**DES CSIRO/GA GDEMP 11b Advice request – REVISED based on CSIRO/GA feedback and clarification provided 20 May 2019**

**Subject: Review of Carmichael Coal project Groundwater Dependant Ecosystem Management Plan**

### Adani Mining Pty Ltd – Groundwater Management Plans

Advice on Groundwater Management and Monitoring and  
Groundwater Dependent Ecosystem Management plans to the  
Department of the Environment and Energy

Figure 1. Spatial distribution of off-lease monitoring bores. Note that some locations represent nested bore sites. The green polygon shows the Proponent's mining lease areas.

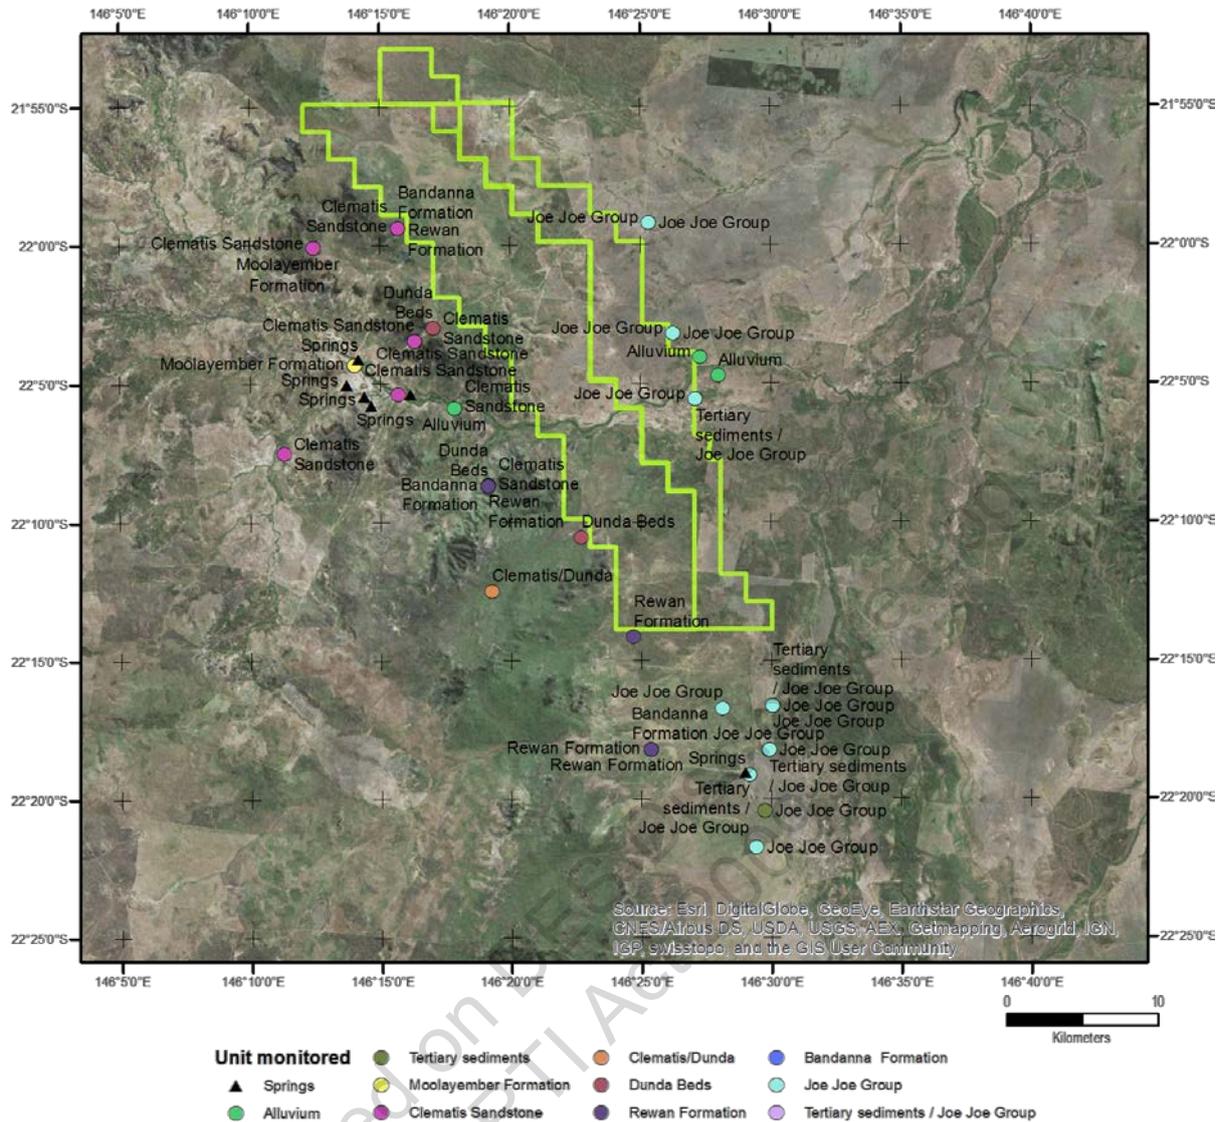
In the GMMP, there are 54 off-lease monitoring bores (Table 1 and Figure 1 below). The off-lease monitoring bores are primarily designed to monitor the Joe Joe Group and the Clematis Sandstone. These are the source aquifers proposed by the proponent for the Mellaluka Springs and DSC respectively. The monitoring network set out in the GMMP for the Mellaluka Springs appears adequate, given that these are sourced from the Joe Joe Group and Tertiary<sup>1</sup> sediments.
